SPARTAN CHASSIS, INC.

TSB09-530-001

TECHNICAL SERVICE BULLETIN

SUBJECT: Lighting – Overhead Dome

FIG. 3-1

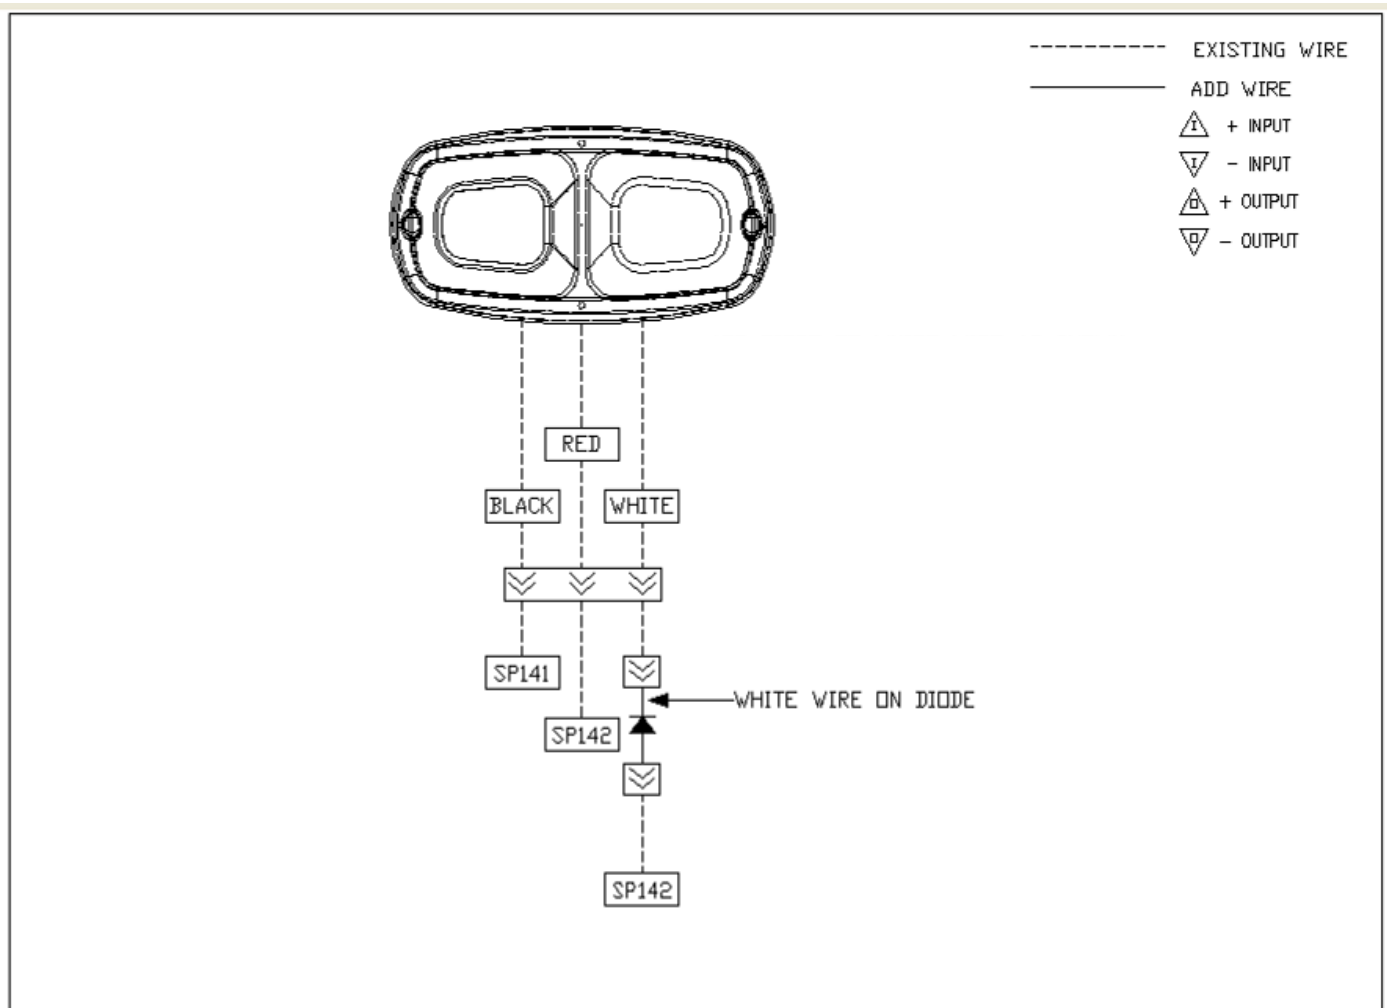
CONDITION: When manually activating the white/clear portion of the dome light via the switch on the light, both the light on the right and left side of the truck come on.

6. Locate 3-way connector in cab raceway next to dome light.
7. Locate SP142 wire that is connected to the white wire of dome light.
8. Cut SP142 wire (white) 2" from dome light and strip approximately 1/8" of coating from each end of wires.
9. Cut eyelet from diode and strip approximately 1/8" of coating from wire.
10. Crimp male spade terminal (0636-GG5-D02) to white wire of diode, add male connector (08900420).
11. Crimp female spade terminal (0636-GG5-D08) to SP142 wire coming out of 3-way connector, add female connector (02977253).
12. Crimp male spade terminal (0636-GG5-D02) to opposite end of SP142 wire, add male connector (08900420).
13. Refer to FIG. 3-1. Connect the diode into circuit as shown.
14. Repeat on all red/clear dome lights above cab doors.
15. Reinstall headliner using hardware retained in previous steps
